North Dakota Department of Transportation

ADDENDUM 1 – JOB 2

TO: All prospective bidders on projects SOIA-7-085(096)192, Job No. 2 scheduled for the May 22, 2014 bid opening.

SRF No. 7594

Revised 5/12/2014	STATE	PROJECT NO.	SECTION NO.	SHEET NO.
	ND	SOIA-7-085(096)192	100	35

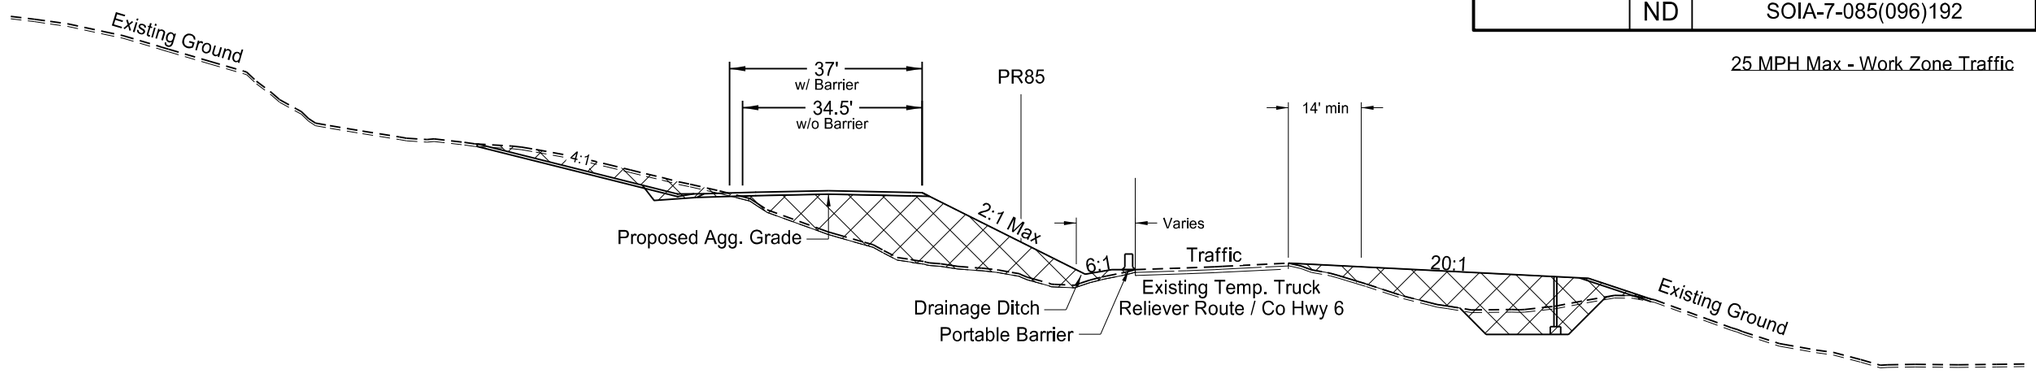
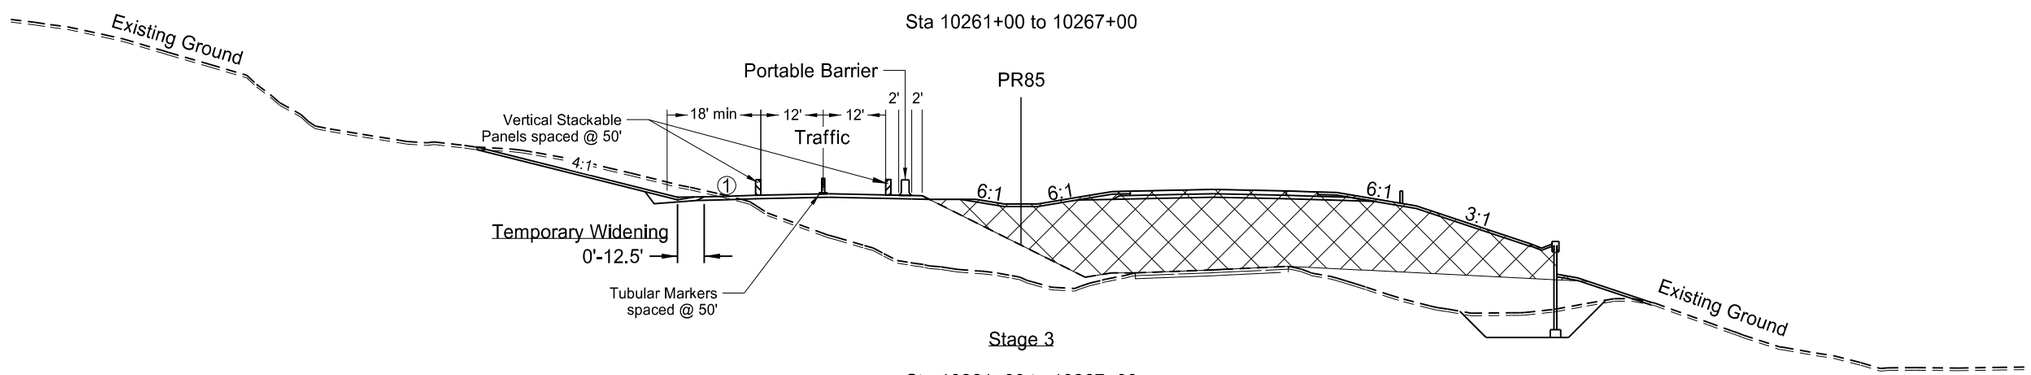
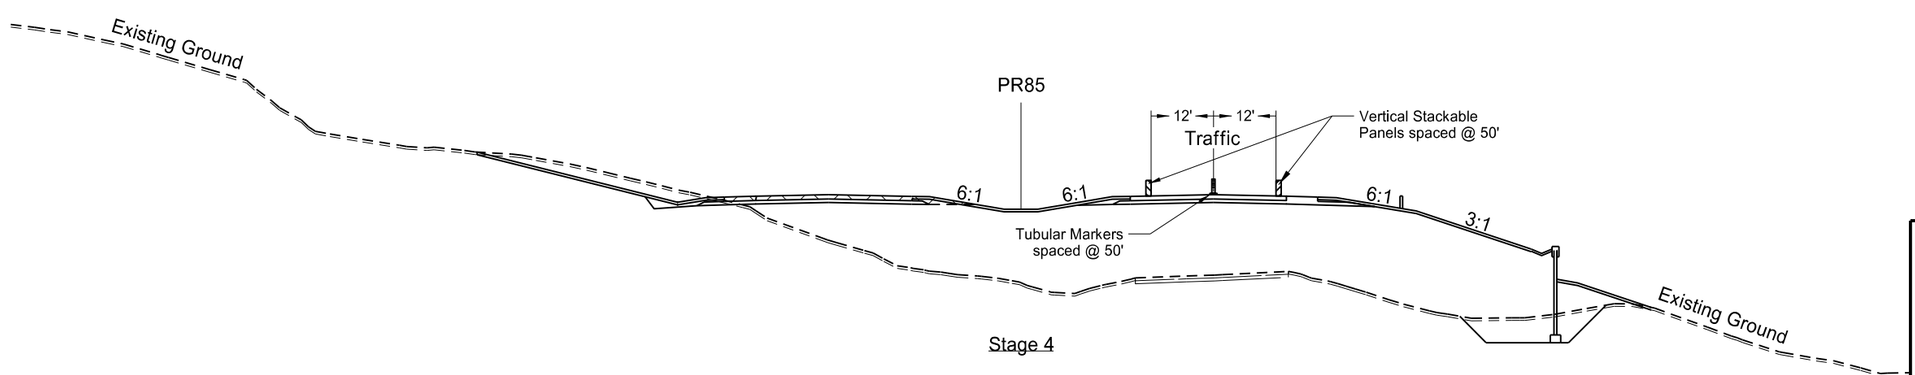
Sheet 100-35:
Revised typical section to reflect the distance of the retaining wall from the roadway.

Revised 5/12/2014	STATE	PROJECT NO.	SECTION NO.	SHEET NO.
	ND	SOIA-7-085(096)192	130	2

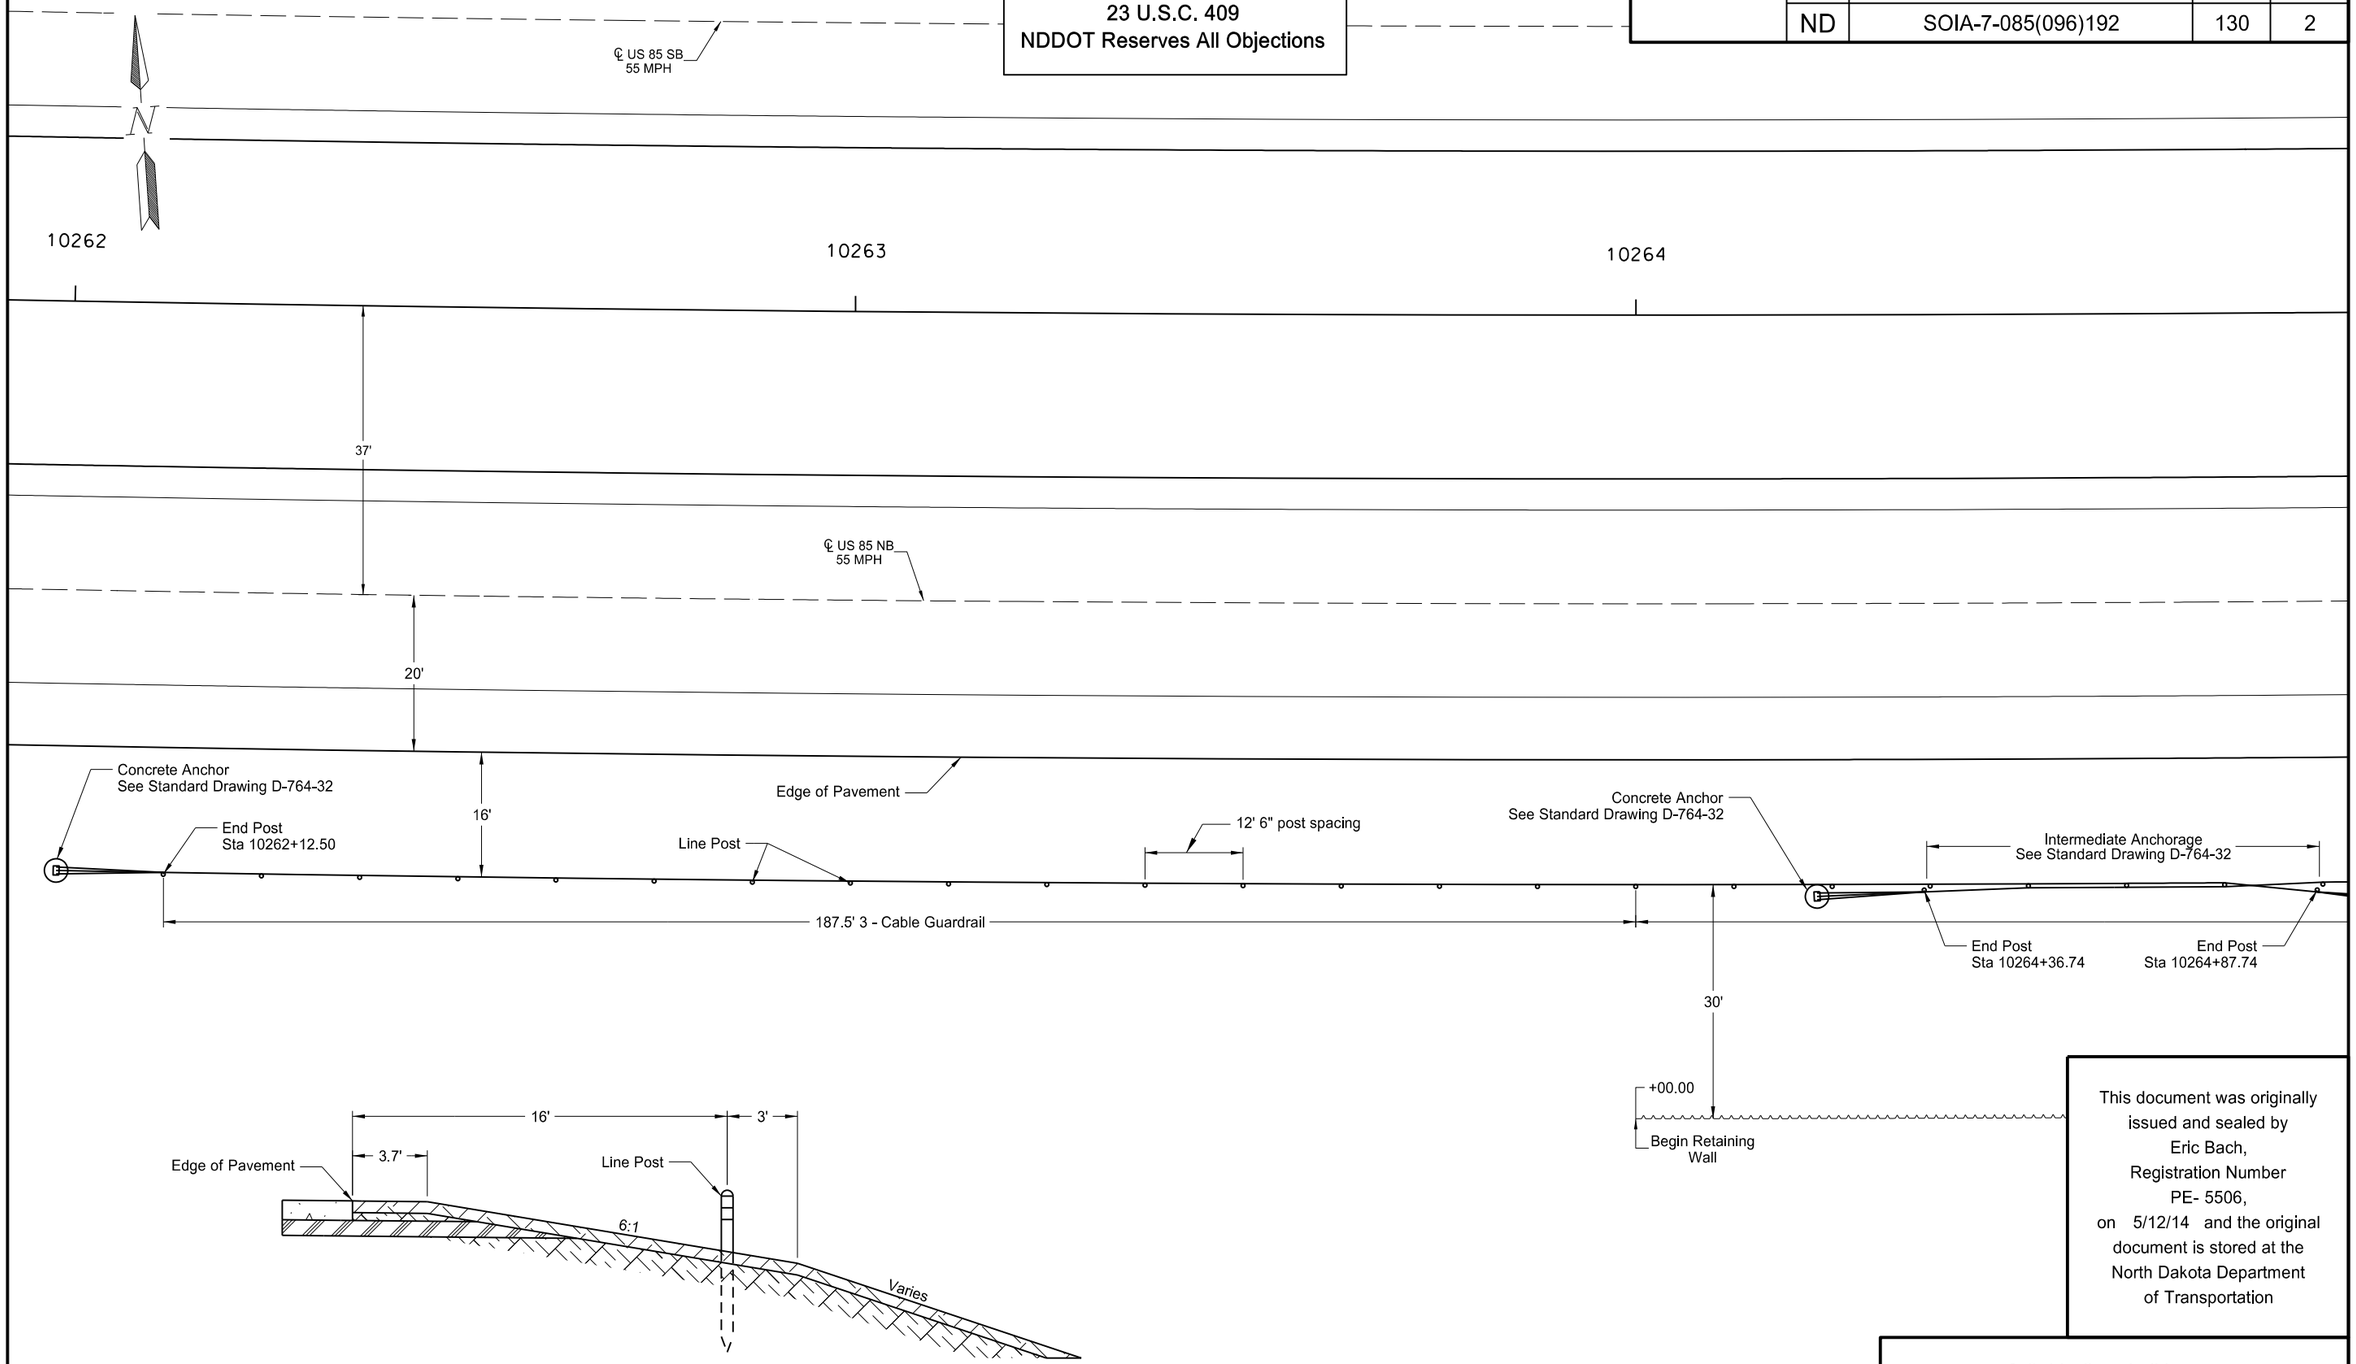
Sheet 130-2:
Revised guardrail due to change in retaining wall.

Revised 5/12/2014	STATE	PROJECT NO.	SECTION NO.	SHEET NO.
	ND	SOIA-7-085(096)192	130	3

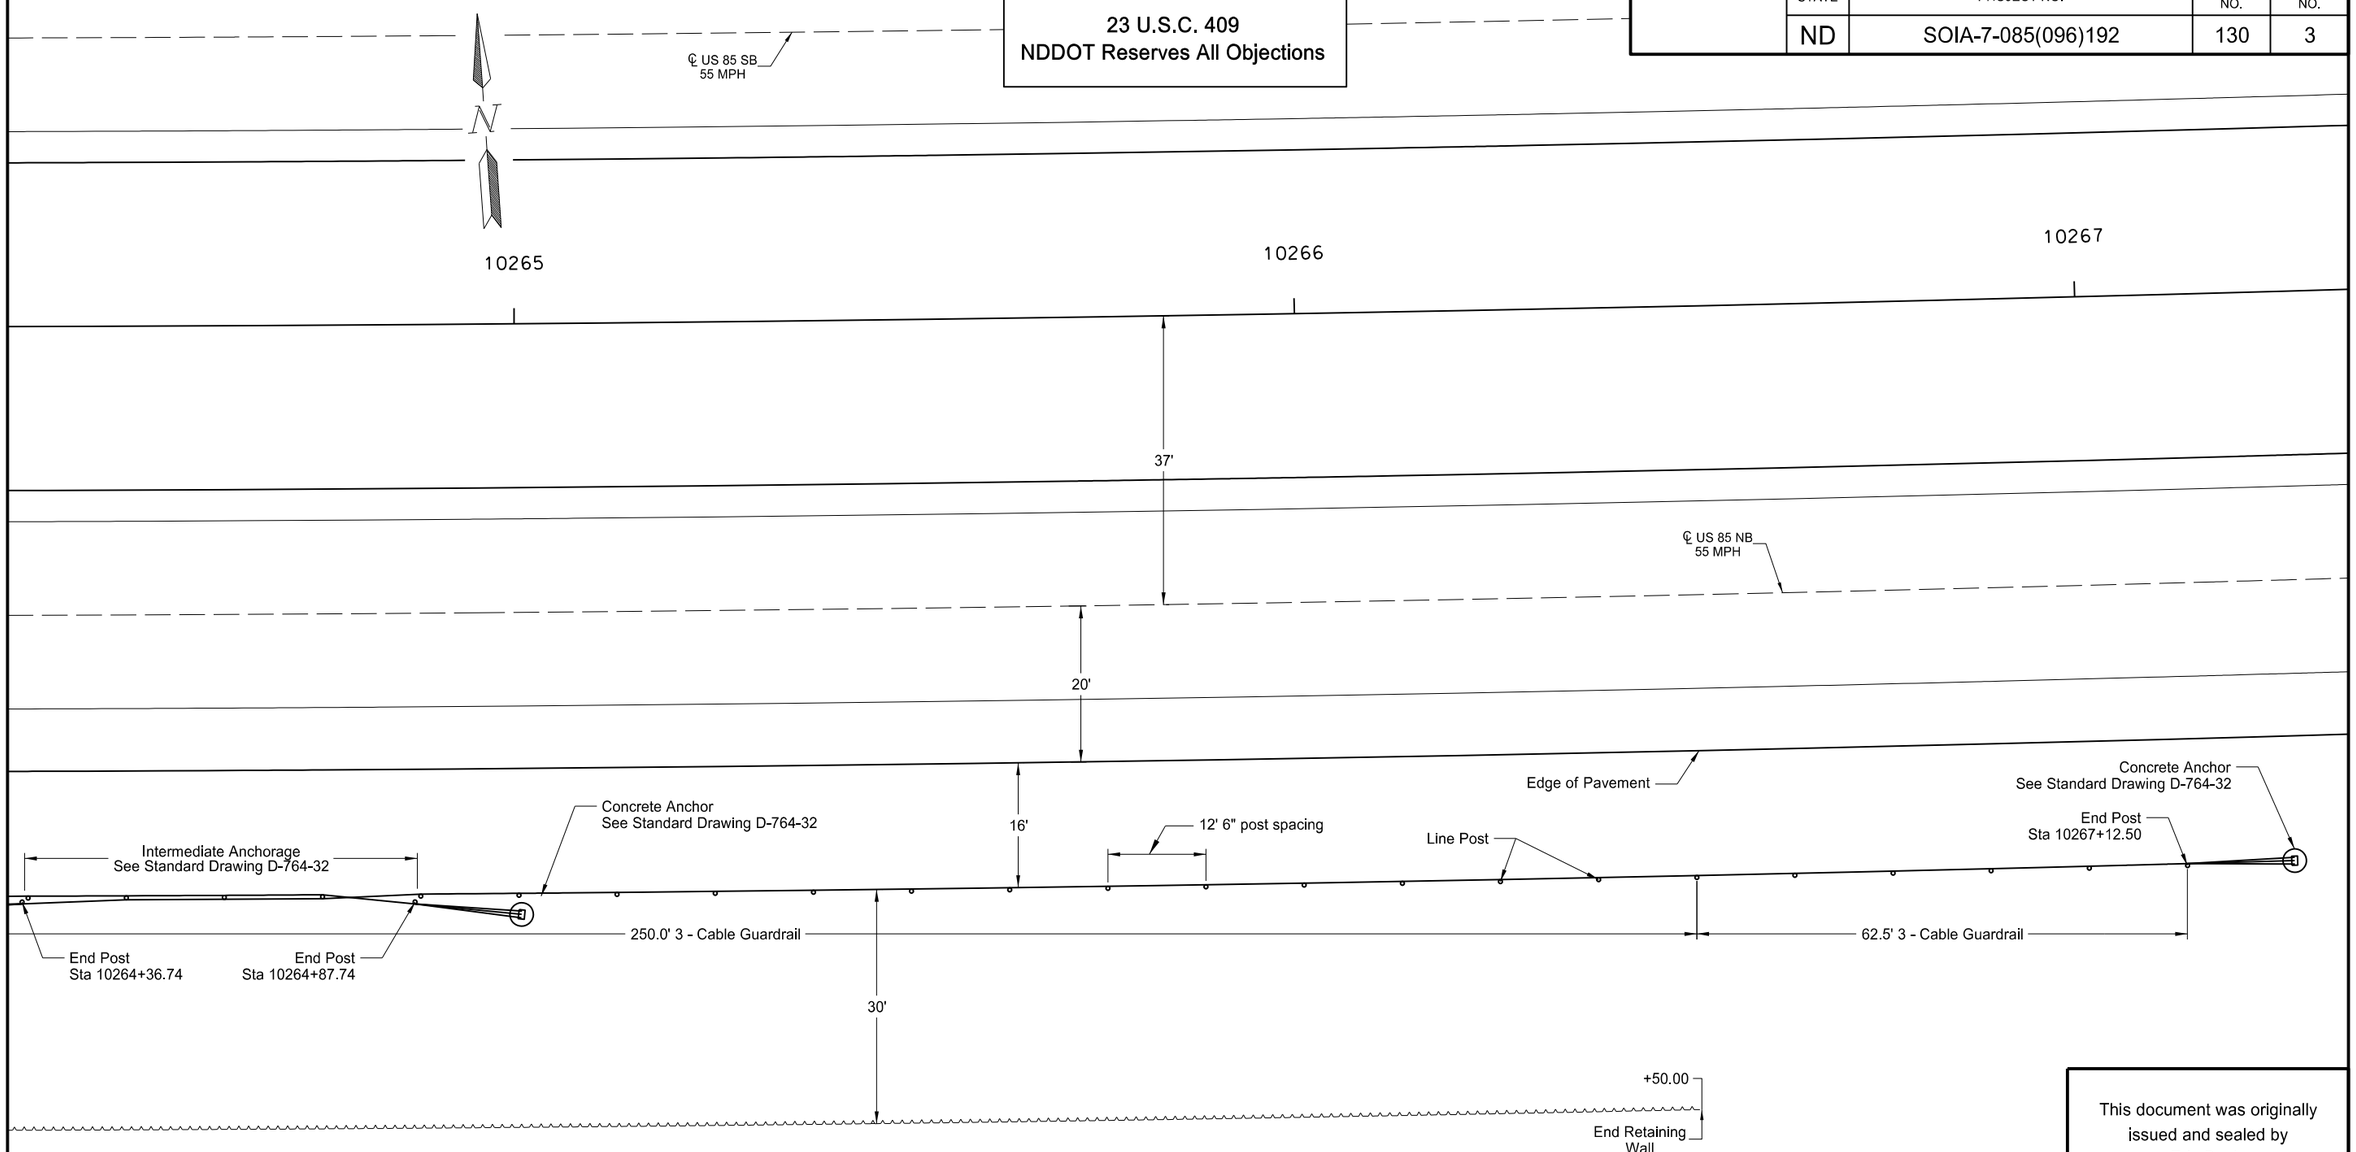
Sheet 130-3:
Revised guardrail due to change in retaining wall.
